PLANNING COMMITTEE AGENDA

Item 6.3

Ref: 19/05428/FUL

Location: 1 Addington Road, South Croydon, CR2 8RE

Image 4: Site layout showing limited outdoor communal areas

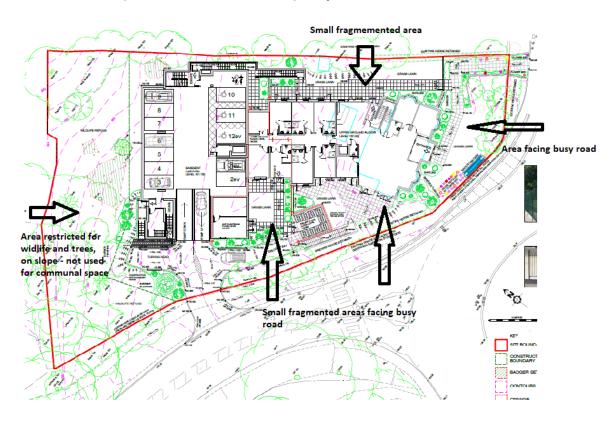
- 8.12 The scheme proposes a single massing that dominates the site, pushing all the outdoor communal amenity spaces to the edges, rather than providing an external communal area that is protected from the effects of traffic noise and pollution, and is better connected with the protected landscaped spaces beyond. There is a general lack of variety, quality, and size of the communal and shared spaces. Apart from outdoor areas which will likely see little active use, the indoor communal spaces are disproportionate in size for the number of bedspaces, concentrated in one part of the building and are small in number. The connection to the internal spaces and the outdoor spaces would also be poor, for example, to gain access to the outdoor spaces; this would only be through the main entrance.

- 8.13 Any development on this site should provide a landscape-led solution and the applicant should consider how the design could provide a comfortable domestic scale so that older residents could form smaller groups within a wider later living complex. Types of functions and space, which add to the quality of life for residents, are absent.

Image 6: Site sections

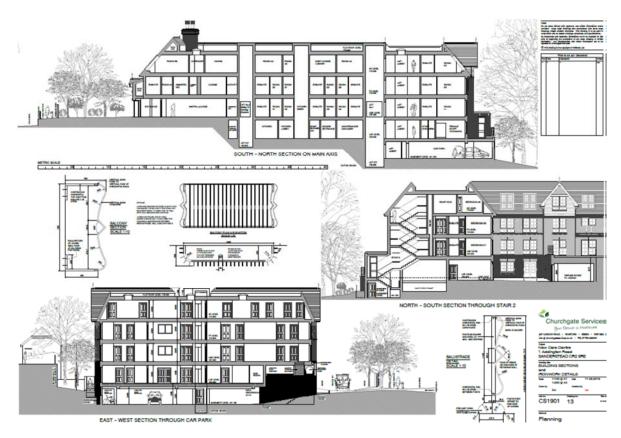
8.15 The care home proposed has a level ridge with two semi-basements resulting in a building ranging from 2½ to 5 storeys in height. The sloping site would alleviate some of the impact of the scale of the development, however, the increase in massing to five storeys at the rear of the proposal is not considered appropriate to the rear of the site and the surrounding area. This would appear overly bulky and dominant particularly in the context of the character of Sanderstead Hill. It is acknowledged that Sanderstead Heights is a mix of 2-4 storeys in height but is not in such a prominent setting, not as visible from the road and more appropriately follows the topography of the site. No buildings in the local area are of 5 storeys in height. Whilst planting along the boundary would provide some screening, it is considered that the height of the proposal would still be visible along Sanderstead Hill and would be out of keeping with the character of the area.

Image 9: Relationship with surrounding properties

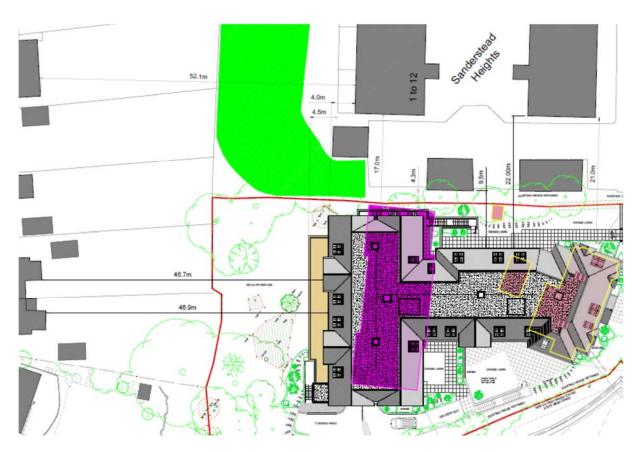
- 8.19 The north-west site boundary faces the rear gardens of the large detached properties in The Woodfields, and the east boundary with the retirement flats at Sanderstead Heights (3 Addington Road). The new development would have generous separation distances of approximately 46 metres to the dwellings in The Woodfields. As such, with the retention of the existing vegetation the development is not considered to appear visually intrusive or lead to a loss of privacy or light to either of these neighbouring properties.
- 8.20 The proposed new development would follow the topography, so it would be lower than the properties at Sanderstead Heights, and given the separation distance of approx. 17m (at the closest point) to the properties at Sanderstead, the impact is considered to be minimal. No other occupiers would be significantly affected.
